**CITY OF BLOOMINGTON
PLAN COMMISSION
April 12, 2021 at 5:30 p.m.**

**BLOOMINGTON PLAN COMMISSION
STAFF REPORT
Location: 2800 Rex Grossman Blvd.**

**CASE #: PUD-11-21
DATE: April 12, 2021**

Date: April 12, 2021
To: Bloomington Plan Commission
From: Bloomington Environmental Commission
Subject: SP-13-21: VIVO Apt. LLC (Wyngate Inn)
1722 N. Walnut Street

1.) **LANDSCAPE PLAN**

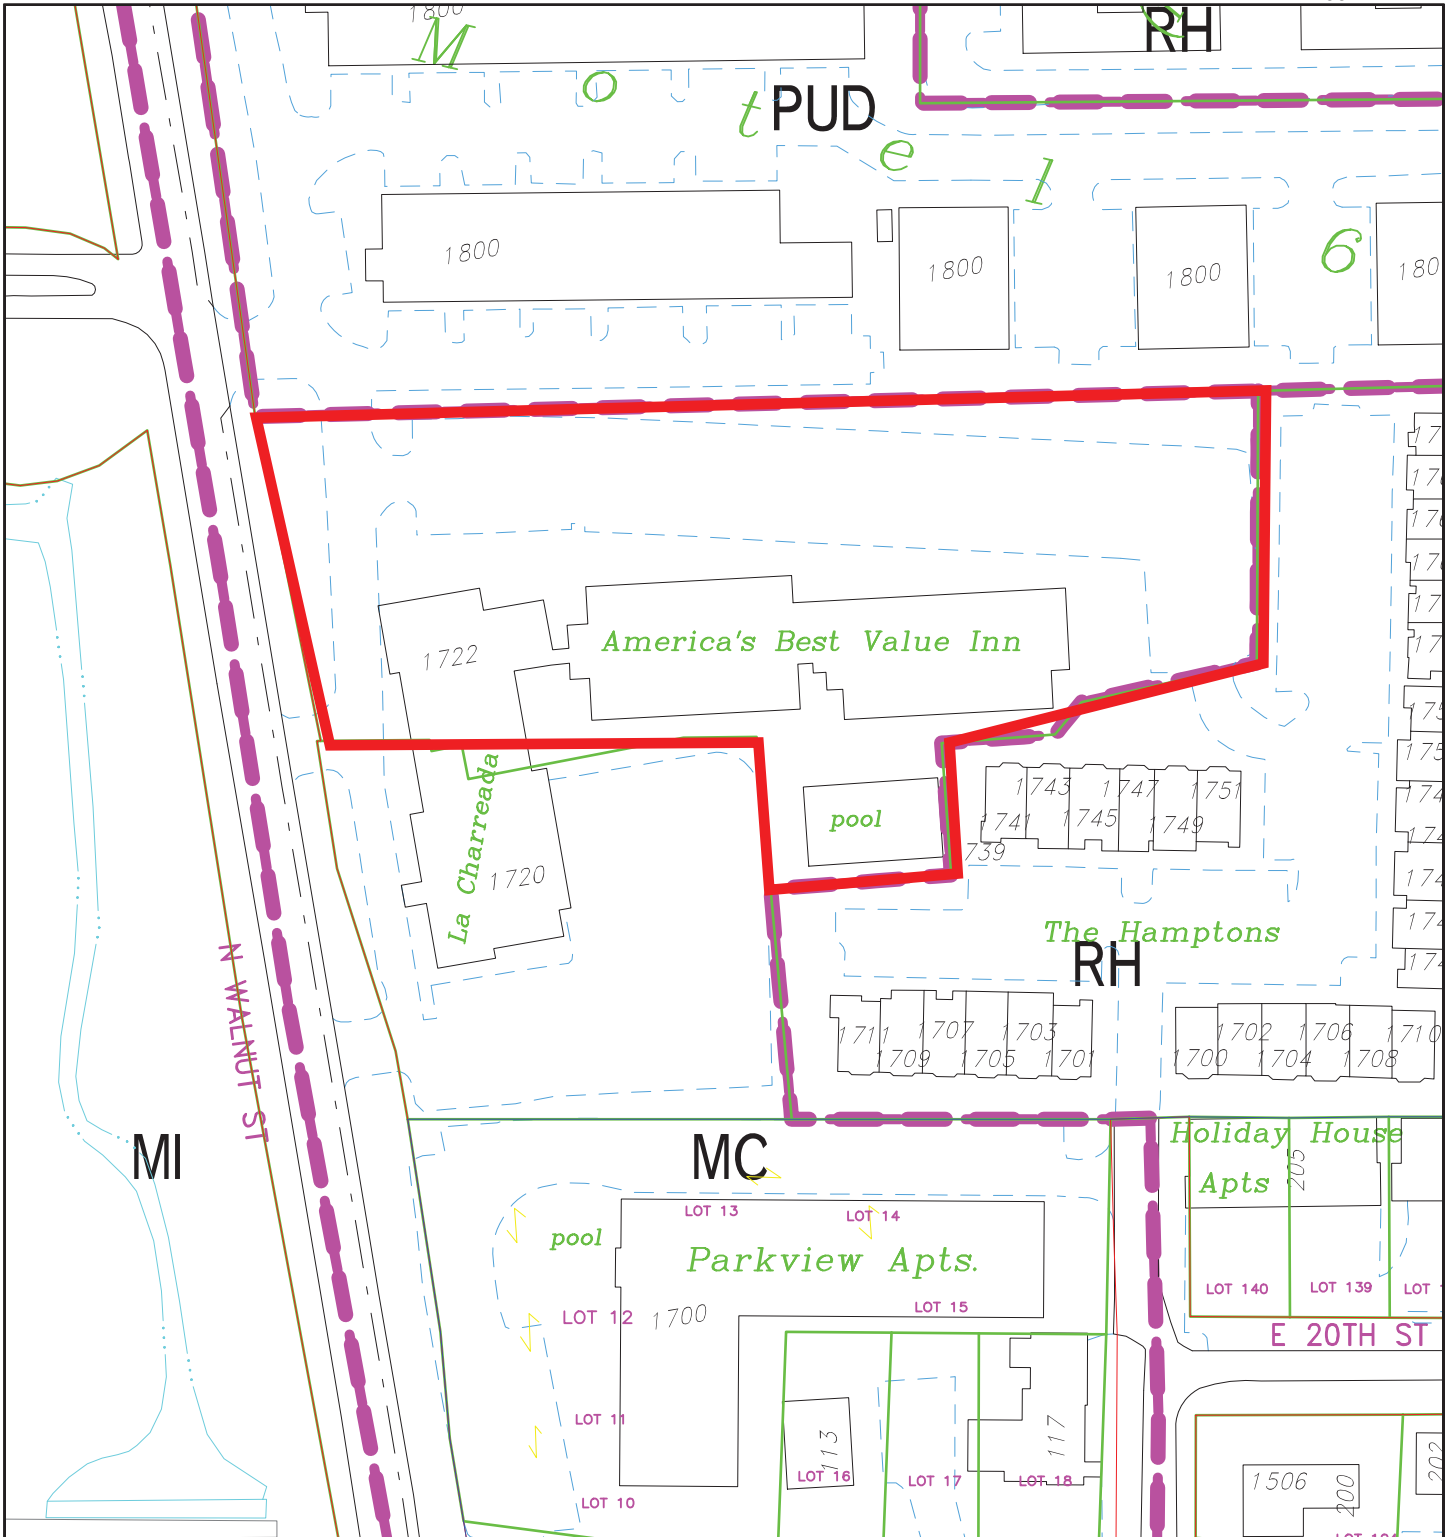
The Landscape Plan needs a bit of revision. The Petitioner has worked early and cooperatively to satisfy the requirements up to this point, thus the EC has no doubts that the plan will take very little to be in compliance.

- 1.) Revise the Landscape Plan prior to the Grading Permit issuance.
- 2.) Use all the green building products possible for the remodel.
